HARTZELL PROPELLER INC.

SERVICE BULLETIN 165E
CODE: C

Inspection for Cracks in Certain Three Blade "Y" Shank Aluminum Hubs

Figure 1. Hub Grease Fittings

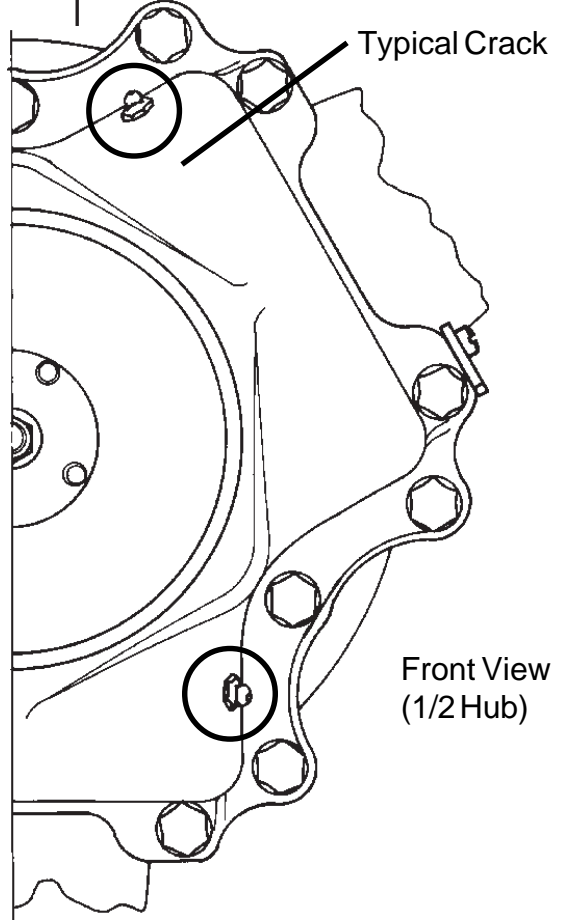
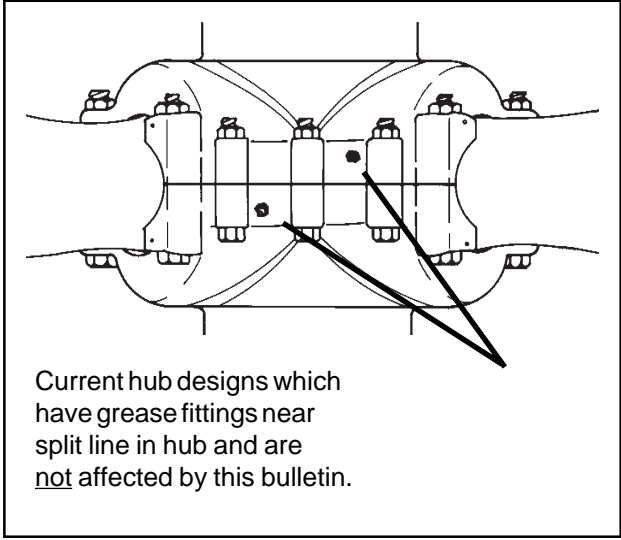
NOTE: During 1983, a hub design change relocated the grease fitting holes near the hub parting line (see Figure 1). The earlier-design hubs are listed as affected serial numbers, however, there may be a few hubs listed that are of the later type. Any hub found to be of the current configuration does not require compliance with this Bulletin. Any hub with the old configuration requires compliance.

3. Use 10X magnifying glass and light source to perform careful visual inspection of the hub for hairline cracks in the general vicinity of blade retention bearings, but primarily inspect the grease fitting areas as shown in Figure 1. Perform inspections with grease fittings installed.

- 2) Scan probe gradually around each of the six grease fittings on the propeller hub. See Figure 1, scan probe in a manner to cross typical crack indications (rather than scanning in strokes that may be parallel to typical crack indications). The center of the probe tip must pass within 1/4 inch of the grease fittings and outward from the fitting as far as practical (up to 2 inches). The initial scanning around the grease fitting should consist of a circle with the probe as close to the grease fitting hole as possible. Perform subsequent scans of concentric circles around the grease fitting with no more than 1/10 inch spacing between circles.

Figure 2. Hub Rework

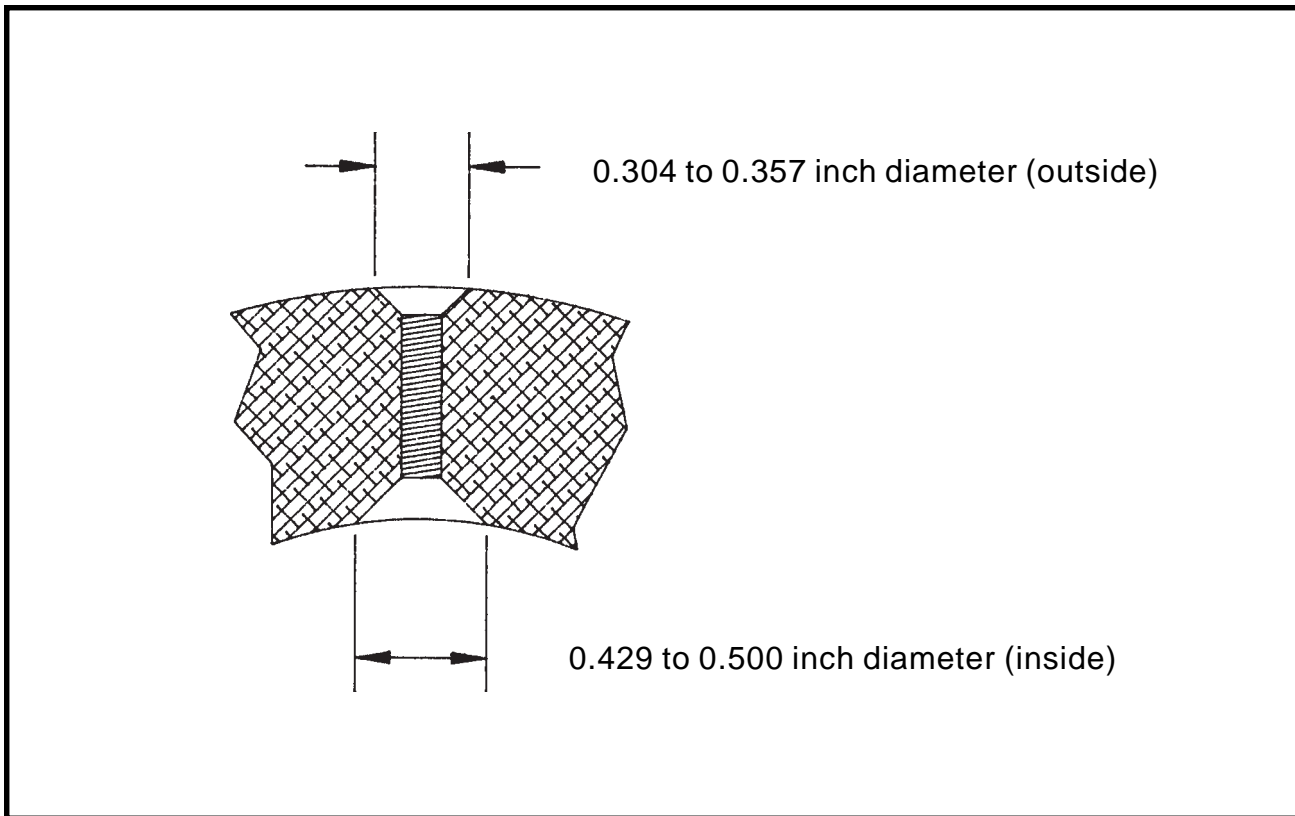
3. Using a 6 fluted, 45° chamfering tool (Hartzell part number 57BST5845), cut a chamfer to 0.429 to 0.500 inch diameter on the inside of the hub at each grease fitting location. Using the same tool, also cut a chamfer 0.304 to 0.357 inch diameter on the external side of each grease fitting hole. See Figure 2.

- a. Chamfering may be performed with a hand-held variable speed drill. Vary the RPM and force on the drill to minimize tool chatter. Testing on a scrap hub is recommended prior to performing this operation.

- b. Check diameter of chamfer using a dial caliper. Hub retirement is required if chamfer exceeds maximum diameter.
4. Polish any sharp edges created by the chamfering tool with 320 grit (or finer) emery cloth or sandpaper.
